Contract #: 04-0120F4Cty: SF/ALA Rte: 80 PM: 13.2/13.9File #: 69.25B**QUALITY ASSURANCE -- NON-CONFORMANCE REPORT****Location:** Changxing Island, Shanghai, P.R. China**Report No:** NCR-000425**Prime Contractor:** American Bridge/Fluor Enterprises, a JV**Date:** 01-Sep-2009**Submitting Contractor:** Zhenhua Port Machinery Company, Ltd (ZPMC), Changxing Island**NCR #:** ZPMC-0399**Type of problem:**

Reference Description: Missed UT Transverse Indication on Transverse Splice of Segment 1AE to 1BE**Description of Non-Conformance:**

REVIEW OF CONTRACTOR'S SUBMITTAL

Critical Welding Repair Report (CWR)

Draft of Welding Discontinuity:

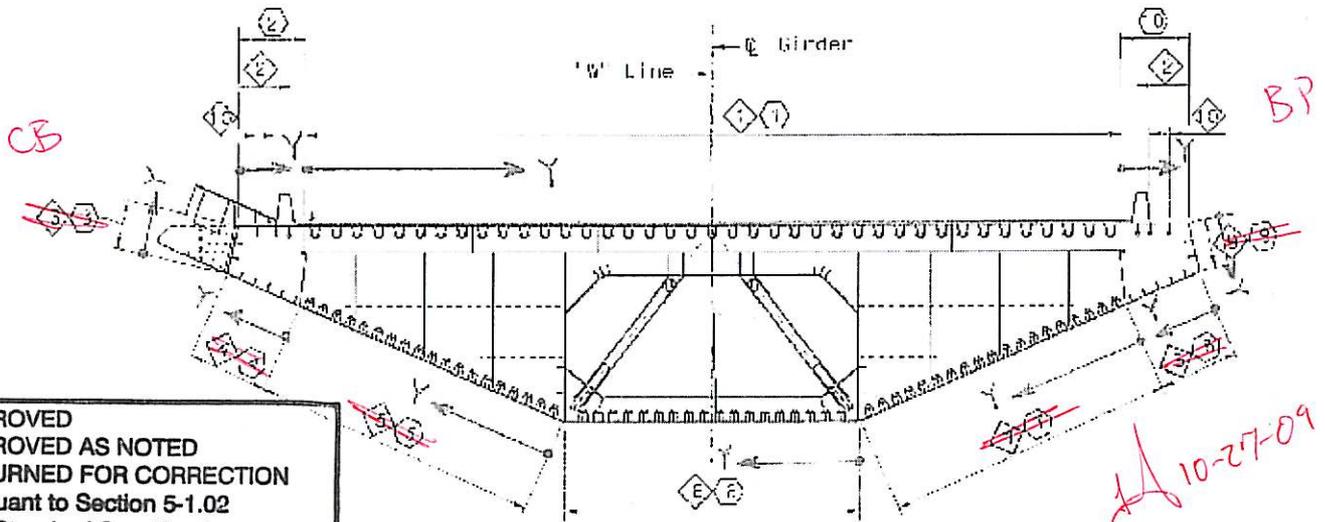
The plate designations in the draft are shown on the opposite sides. Please remove the plate designations in the future to eliminate any possible confusion when laying out these repairs.
